ZONING CHANGE REVIEW SHEETCASE: C14-2023-0047DISTRICT: 3ADDRESS: 1911 Willow Creek DriveZONING FROM: ERC-URTO: ERC-CMUSITE AREA: approximately 10.12 acres (approximately 440,827 sq. ft.)PROPERTY OWNER: 1911 Willow L.P. (Anthony Clarke)AGENT: Drenner Group, P.C. (Amanda Swor)CASE MANAGER: Jonathan Tomko (512) 974-1057, (jonathan.tomko@austintexas.gov)STAFF RECOMMENDATION:

ADDITIONAL STAFF COMMENTS:

Figure 1-2: East Riverside Corridor Subdistrict Map with Property outlined in red:

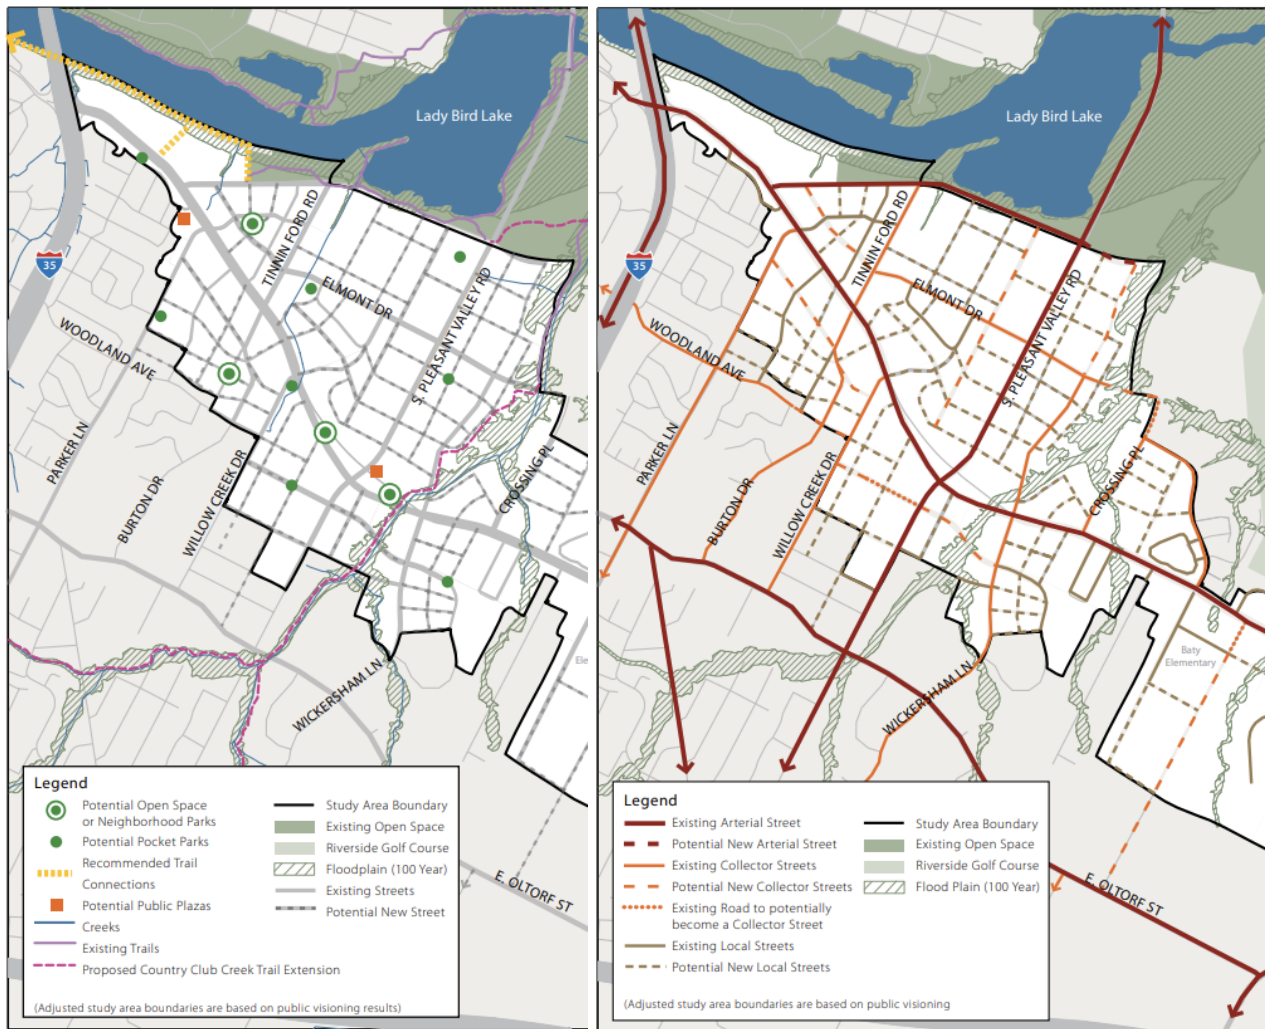
UD1: The applicant is requesting a zoning change from ERC-Urban Residential to ERC-Corridor Mixed Use. The applicant does not specify a desired height but does propose 1,200 units of multifamily development. Currently, this Property is within the Hub boundary (Figure 1-6) and eligible for a 65-foot height bonus (Figure 1-8). The ERC-CMU property to the north is eligible for a 120-foot height bonus. The map below is a screenshot of Figure 1-2 from the Regulating Plan with the Property circled in red.
